Memo

Re: Magruder Pointe Development, Detailed Site Plan 18005 – City Council Action

The purpose of this memorandum is to provide the City Council with recommendations related to Detailed Site Plan 18005, Magruder Pointe Development.

Exhibit 1. Lots 20 & 22, Shared Area Dedicated to HOA

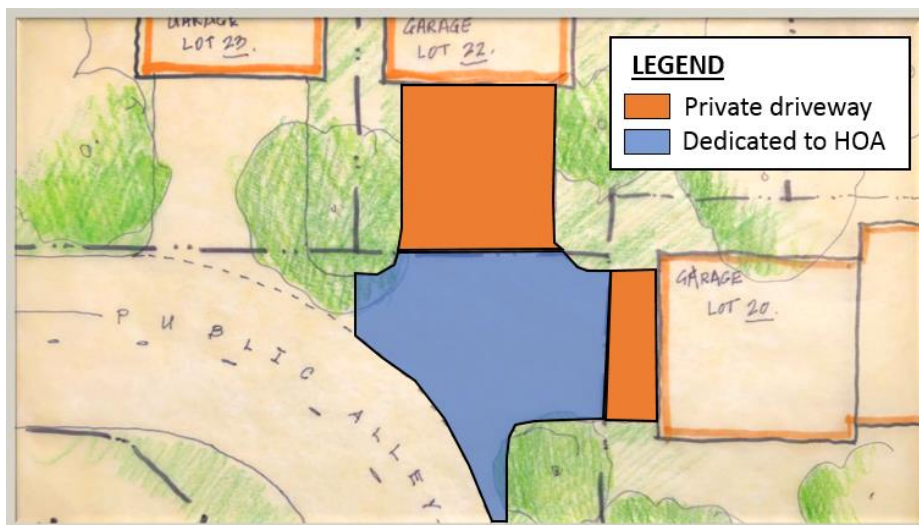
2. *The shared driveway area between Lots 20 and 22, which does not reside on private property, shall be entrusted to the site's HOA for ownership and maintenance, as proposed in the City's Exhibit 1, submitted for the record.*

All lots, except Lot 21 at the corner of Hamilton Street and 41st, have rear loading garages that are accessed via an internal public alleyway through the site. On the eastern side of the site, where the alley turns south, Lot 20 and Lot 22 meet. In order to connect the driveways on these lots to the public alley, the driveways extend off the lot properties and create a connected, shared driveway area.

Department of Public Works Staff indicated that their preference would be for Lots 20, 22, and 23 to each have a separate driveway apron. This would create a clear division between each driveway and prevent potential maintenance conflicts. DPW Staff explained that in order to ensure all lots have their own driveway apron, the paving of the public alley would need to extend further east. This will make the space easier for DPW to maintain, as opposed to the configuration requested by the applicant.

If reconfiguring the alleyway in this manner is not feasible, Staff is open to having the shared driveway space be entrusted to the HOA for ownership and maintenance. This option will also ensure that maintenance of this space does not fall to DPW Staff. A visual depiction of this option can be seen in Exhibit 1, while the extended alley option can be seen in Exhibit 2.

Exhibit 2. Lots 20 & 22, Extended Alley

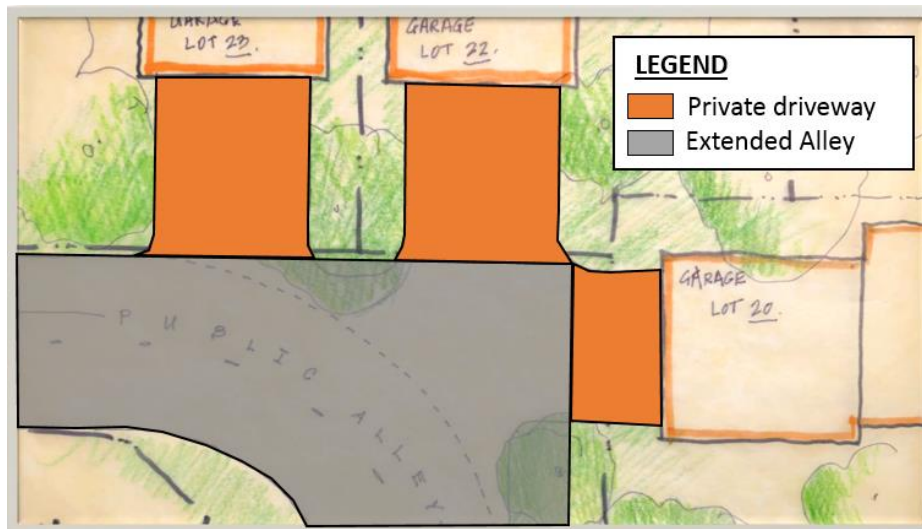
All lots shall have separate dedicated driveway aprons as proposed in the City's Exhibit 2, submitted for the record.
